DISPUTE REVIEW BOARD RECOMMENDATION

RE: FPN: 257093-1-52-01, 257093-1-56-01, 257093-1-56-02
Contract No. 21362
Memorial Causeway
Pinellas County
Disputes Review Board

Issue # 1 - "Is it the Contractor's responsibility to design and construct temporary drainage systems to accommodate storm water runoff generated from outside the project limits?"

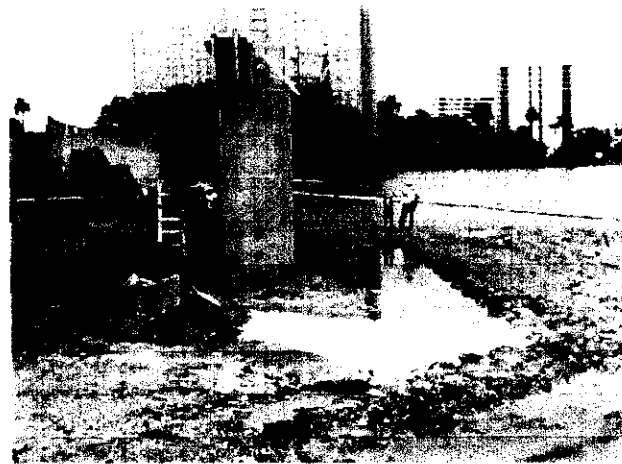
Enormous volumes of water swept the limerock down Pierce Street. Deep gullies exposed proposed utility work.

Deep Trenches were cut through the limerock along Pierce Street.

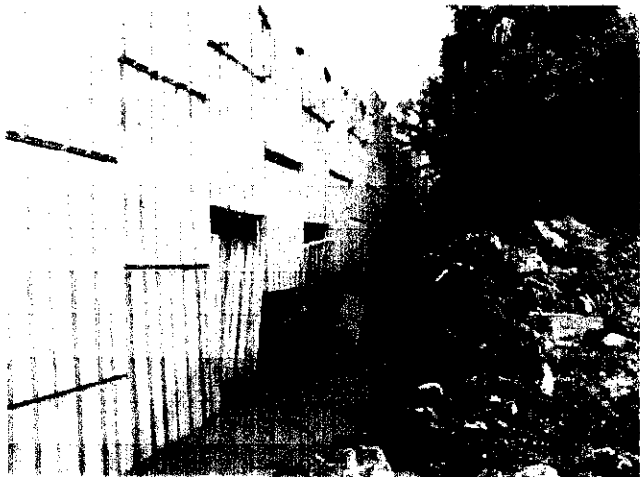
Wall panels along wall #2 were washed out from the top. Geogrid was exposed.
